• TO Greg Shirras FROM Hilary Lough
Hawke's Bay Regional Council DATE 28 July 2020
RE Omarunui Landfill Area B Consent Review – s92 Response Review Summary (DRAFT)

Table 1 - Section 92 questions, summary of T + T response and draft PDP comments on whether the answer satisfies/does not satisfy HBRC's information requirement

OMARUNUI LANDFILL AREA B - CONSENT REVIEW – S92 RESPONSE REVIEW SUMMARY (DRAFT)

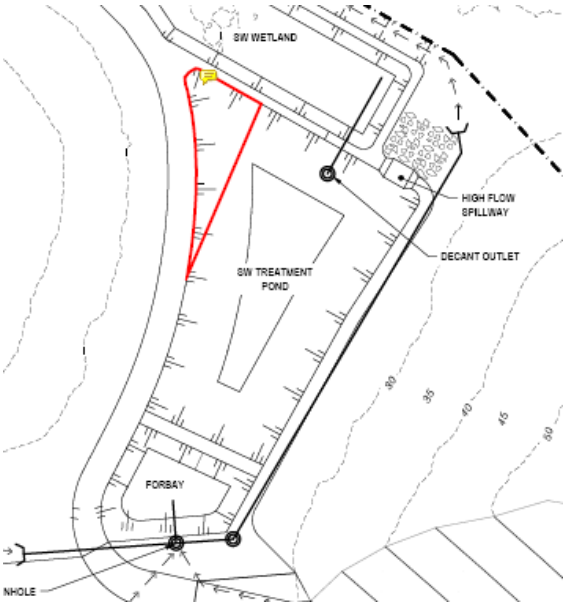
<p>c) An indication of the likely performance of the sediment pond during storm events greater than the design storm, and/or how these peak flows will be managed and/or if they will mobilise contaminants in the sediment pond and/or wetland;</p>		<p>The response states that for storms in excess of the 10 year event, flows will bypass the wetland, indicating that storms up to and including the 10 year storm would pass through the wetland. In order to assess the potential for sediment and contaminants becoming re-entrained, the Applicant has calculated the peak flows in the Area B pond and wetland. For the Area B pond, the flow has been calculated to be 0.03 m/s during the 1:10 year event and 0.05 m/s during the 1:100 year</p>	<p>Response considered acceptable.</p>

<p>event. For the wetland, the flows are reported to be 0.1 m/s during the 1:2 year storm and 0.2 m/s during the 1:10 year storm.</p> <p>Based on the calculated peak velocities, the applicant considers remobilisation of sediment unlikely. We agree with the Applicant that the calculated velocities are sufficiently low to reduce the risk of remobilising sediments and contaminants.</p>	
	<p>d) How the potential risk of spills, for example from machinery and vehicles operating during the construction and operation of the landfill will be managed;</p>	<p>The Applicant responded that the existing Landfill Management Plan includes spill response measures, which will continue to be implemented during Stage B. The Applicant therefore considers the existing controls are appropriate, and does not propose any changes.</p> <p>Section 6.8.2 of the original application refers to the Omarunui Landfill Management Plan in Appendix 24 of the Proposed Hastings District Plan. We have checked Appendix 24 of the Proposed Hastings District Plan, and we could not find any reference to the potential risk of spills. However, Appendix F of the original application contains the O&M manual for the landfill, which in ‘Section 20.3.13 Accidental Spillage of oil or Grease within site’ states:</p> <p><i>“Ensure material does not enter the vegetated area by isolating the stormwater pond. The material is to be skimmed or pumped off and deposited in the landfill. Use spill kit in the staff compound to contain spills in the compound area. Refer to Emergency Management Manual – see Landfill Fires section of this manual same link”</i></p> <p>It appears the Applicant’s response intended to refer to the O&M manual. Clarification from the Applicant is therefore requested if our interpretation is correct. If yes, we note that the Applicant has stated the existing controls will remain in place, which as per above includes isolating stormwater ponds if necessary, use of spill kits, and/or skimming/pumping of the spill. We would therefore consider the</p>	<p>Clarification sought from Applicant. If our interpretation of the response is correct, then we consider the existing controls are sufficient, however O&M manual should be updated to specifically address the risk of spills in Area B.</p>
